Plan Commission

Agenda

Monday, November 25, 2019

SUBJECT: Staff recommendation and possible action regarding a Site Plan request for a new office building and parking lot at 2100 BLK Innovation Court (Parcels WD-D0035-1-1, WD-D0036).

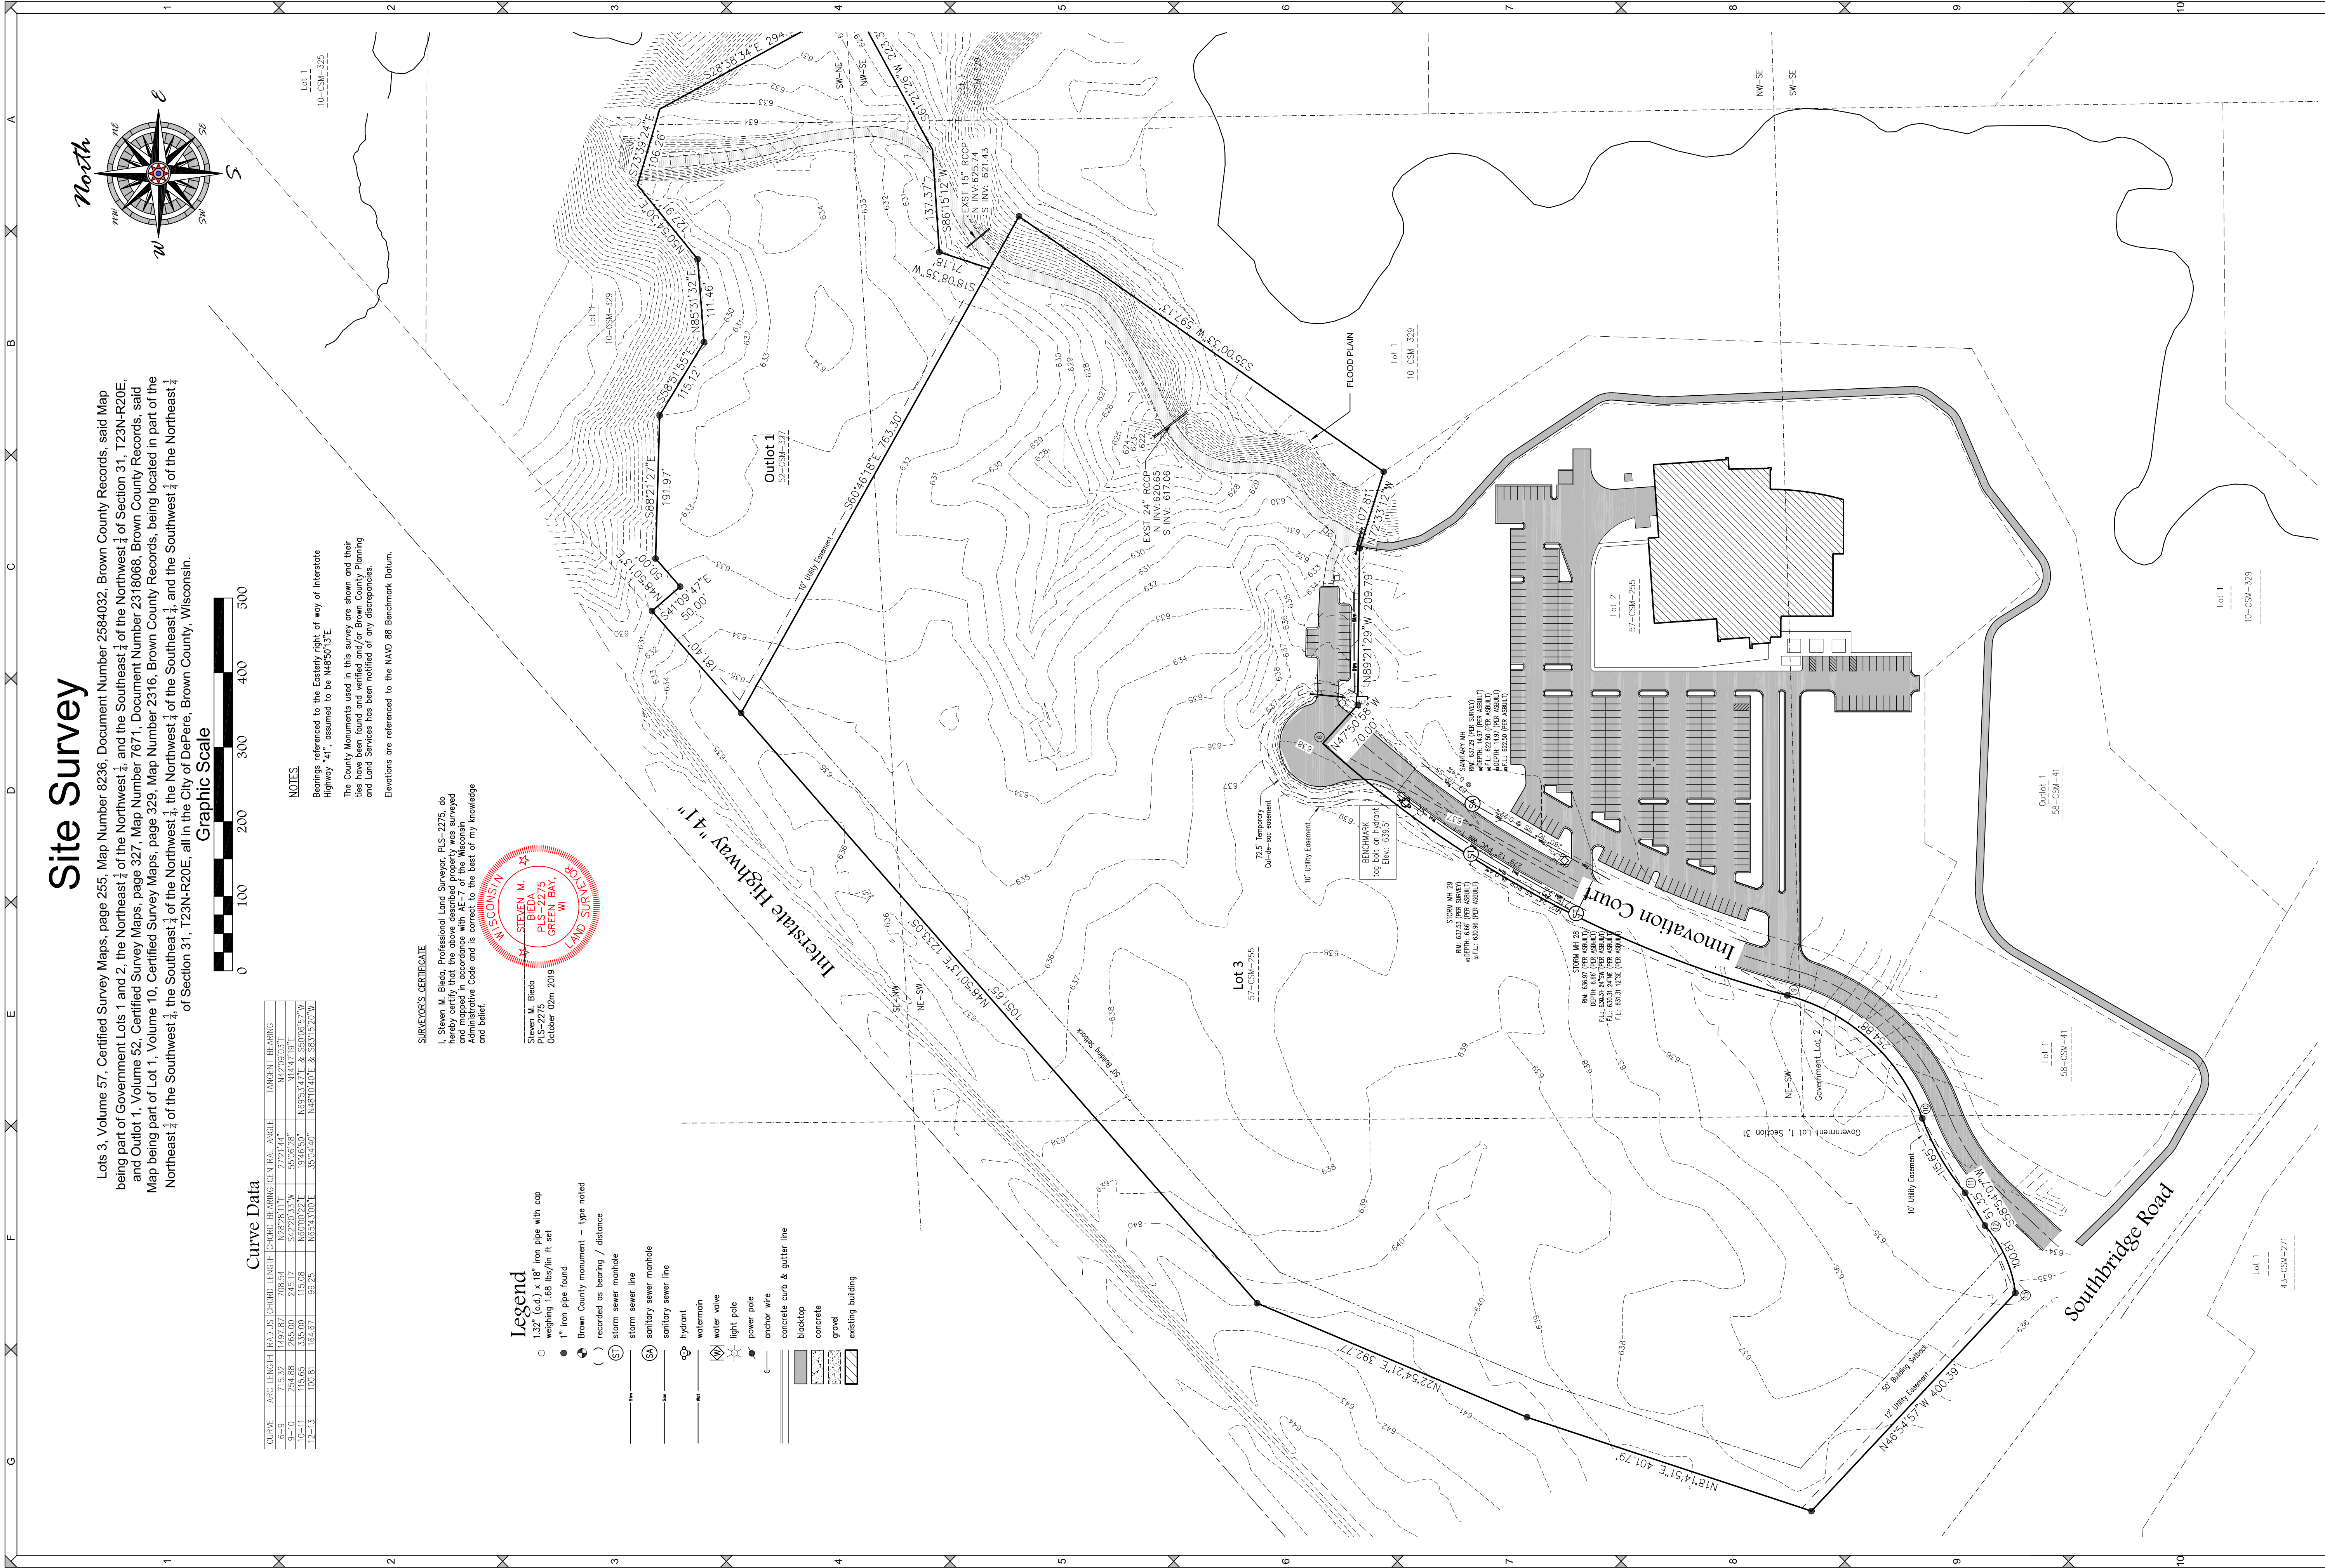
1. Sheet 1 of 1: The property boundaries do not match that of CSM. The parking lot north of Foth is out lot 2 and not part of this development's property. (Throughout plan as well.)

SHEET NO.
C2.0

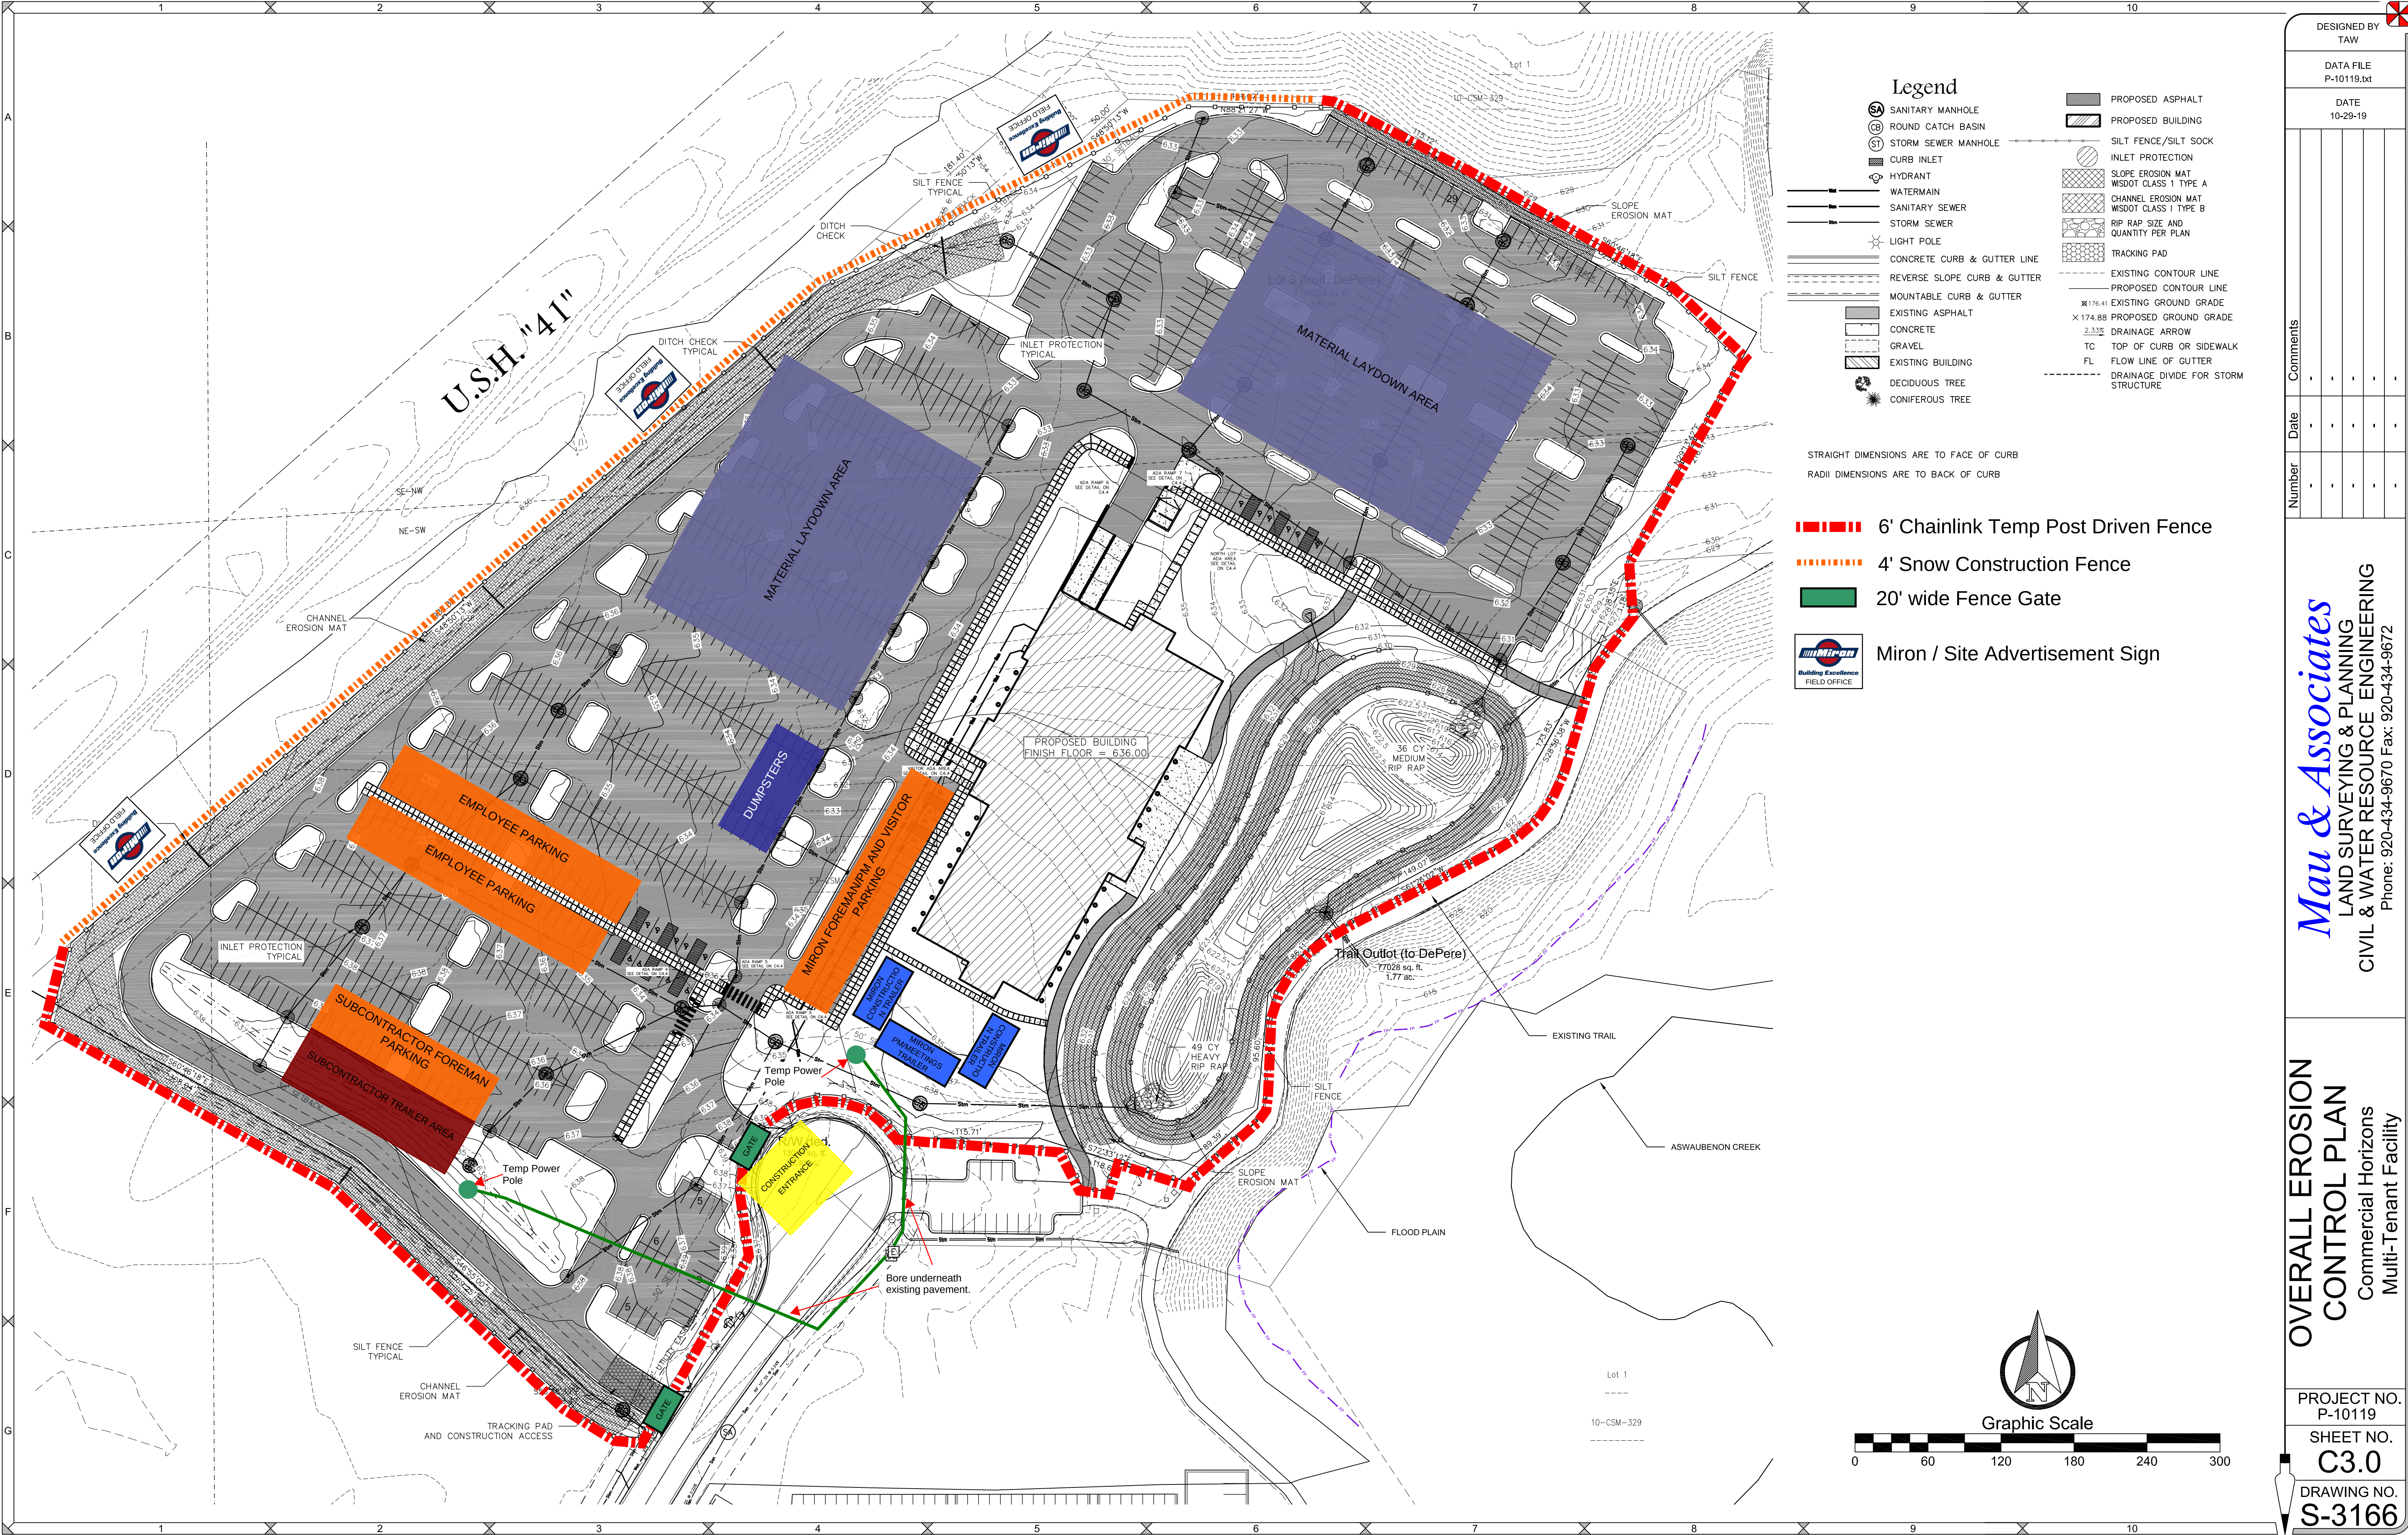
9. Sheet C2.0: Please provide truck turning movements and radii for the truck path in the northern lot and loading bays to verify the shown route is feasible.

- c. Sheet C2.0: It is recommended that the concrete pad at the dumpster enclosure approach be eight-inch concrete to accommodate dumpster pick-up. No detail or hatching is provided for thicker concrete section.

PROJECT NO.
P-10119
SHEET NO.
C2.2
DRAWING NO.
S-3166

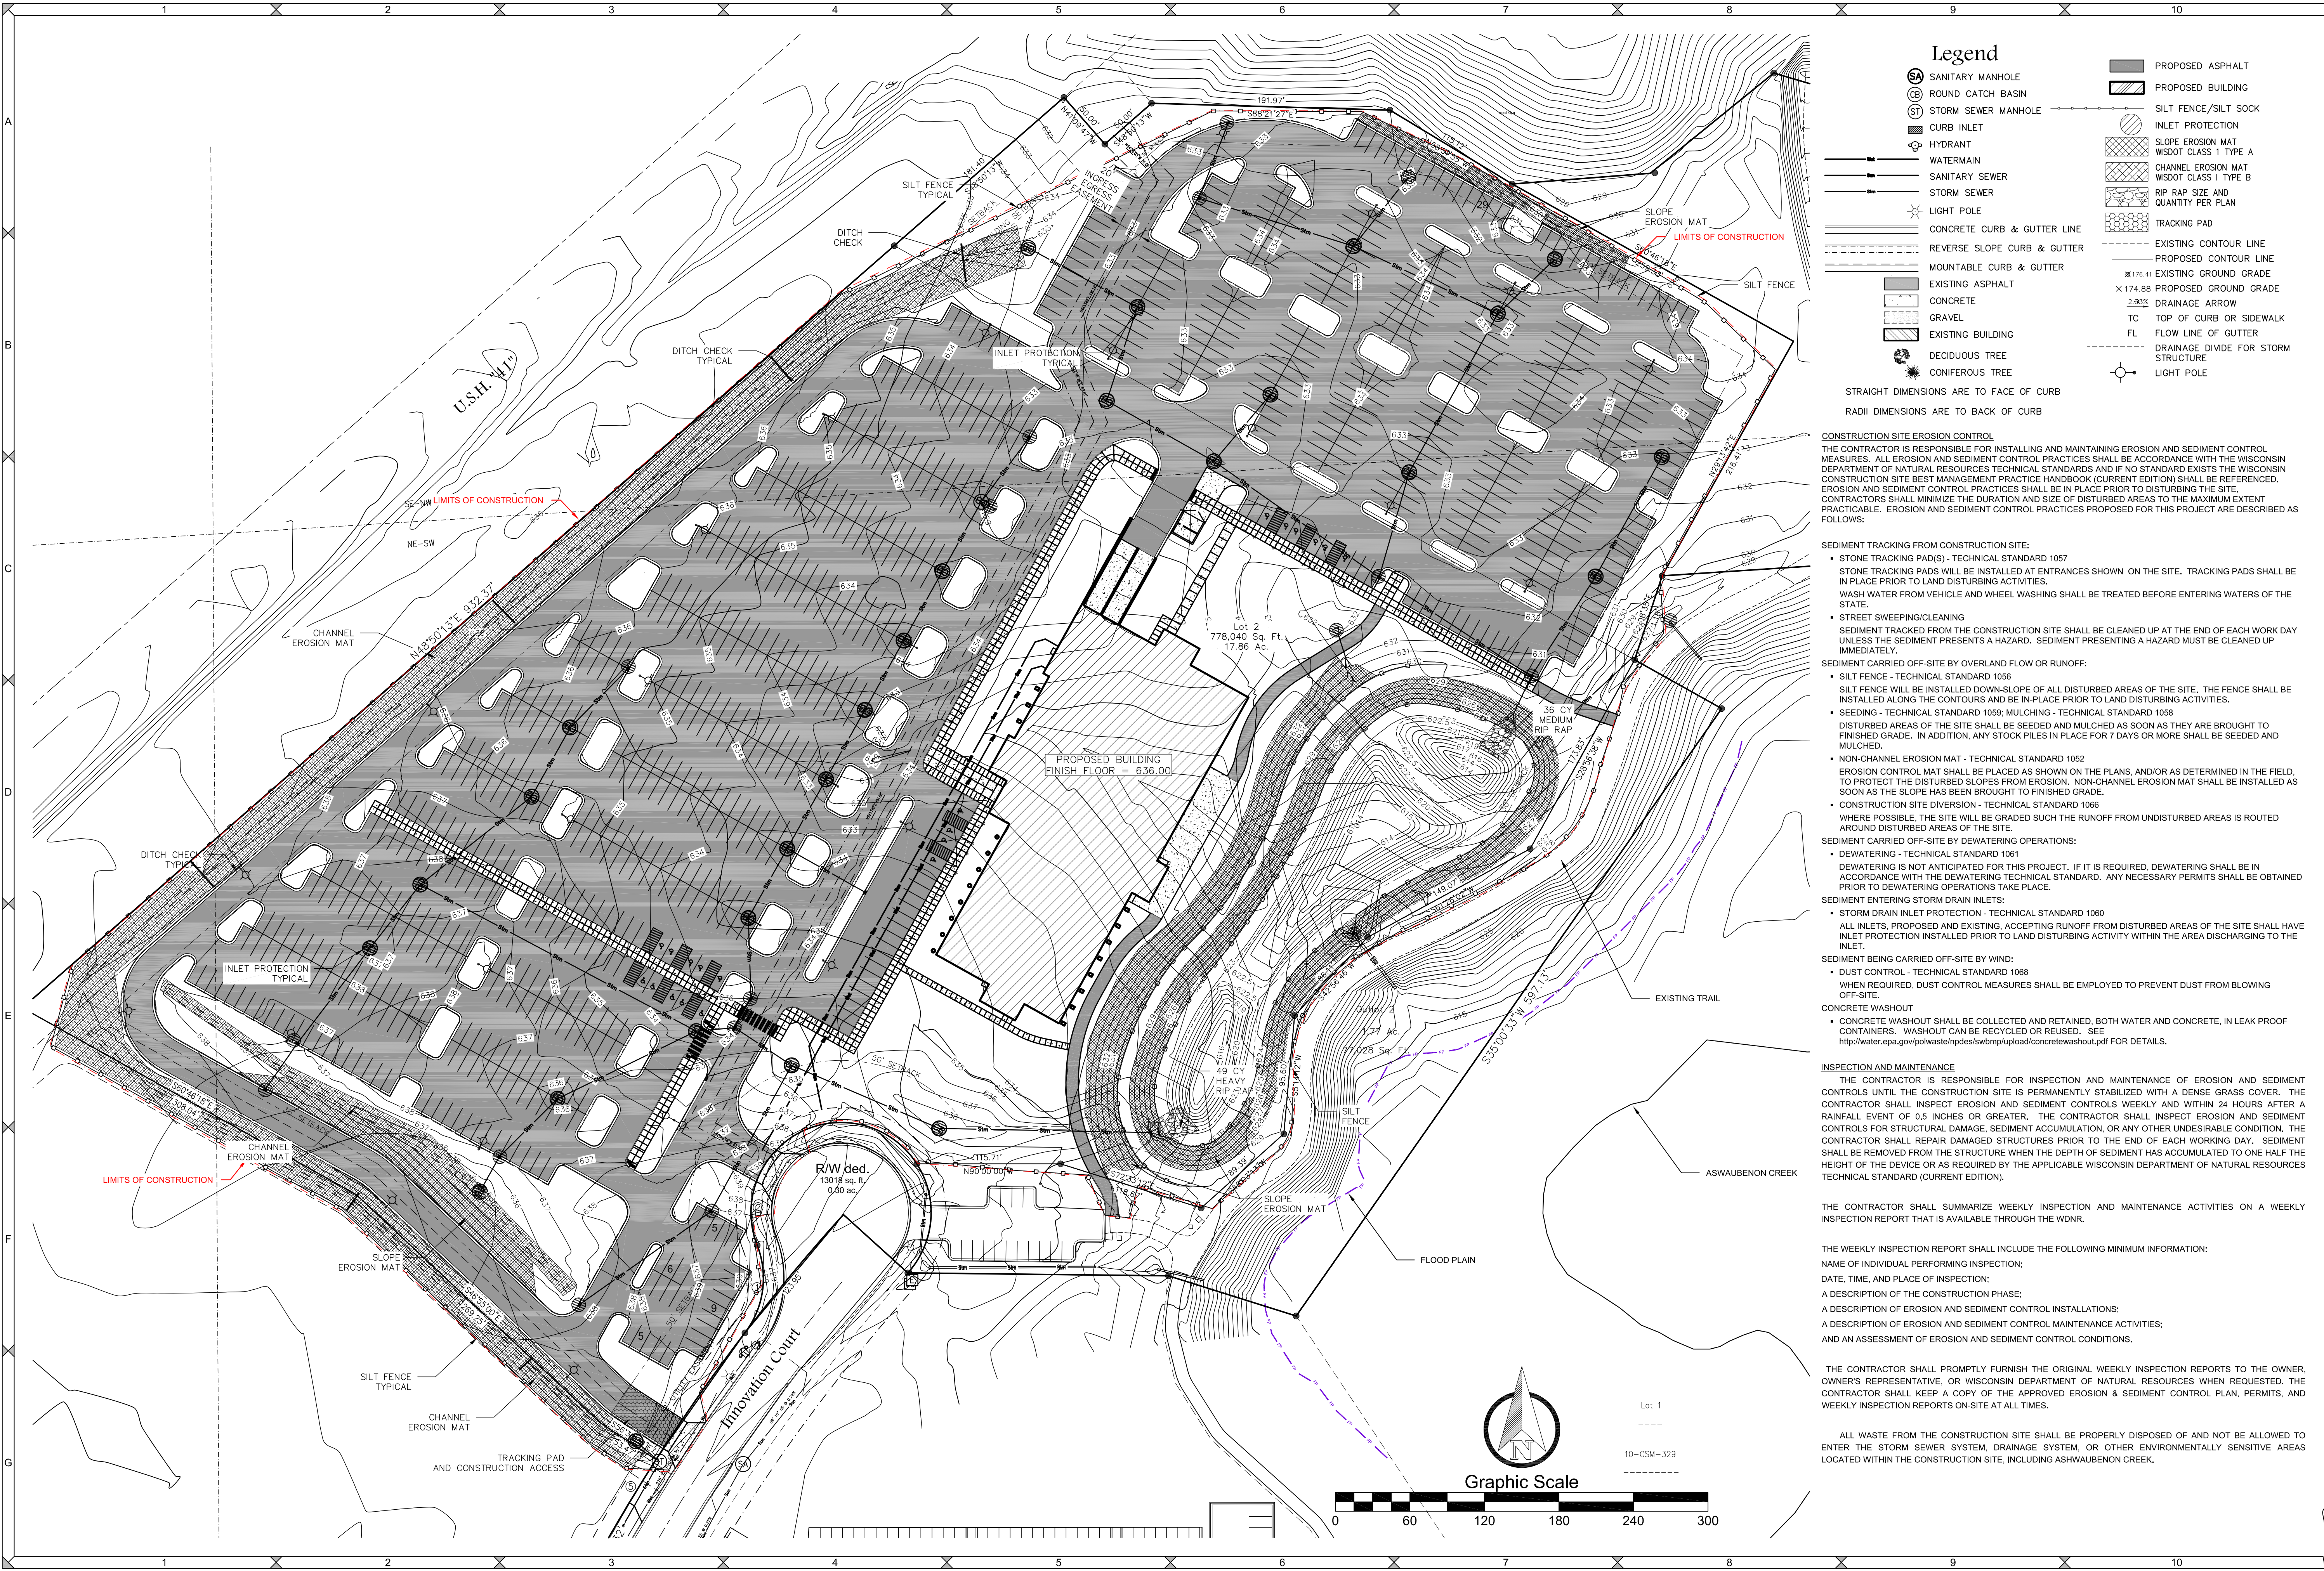
10. Sheet C2.2: Amend comment for concrete curb cut per City of De Pere Specifications to be "concrete curb PROFILE cut..."
11. Sheet C2.2: Show proposed electric, gas, communications lines entering the site and terminating at the building.
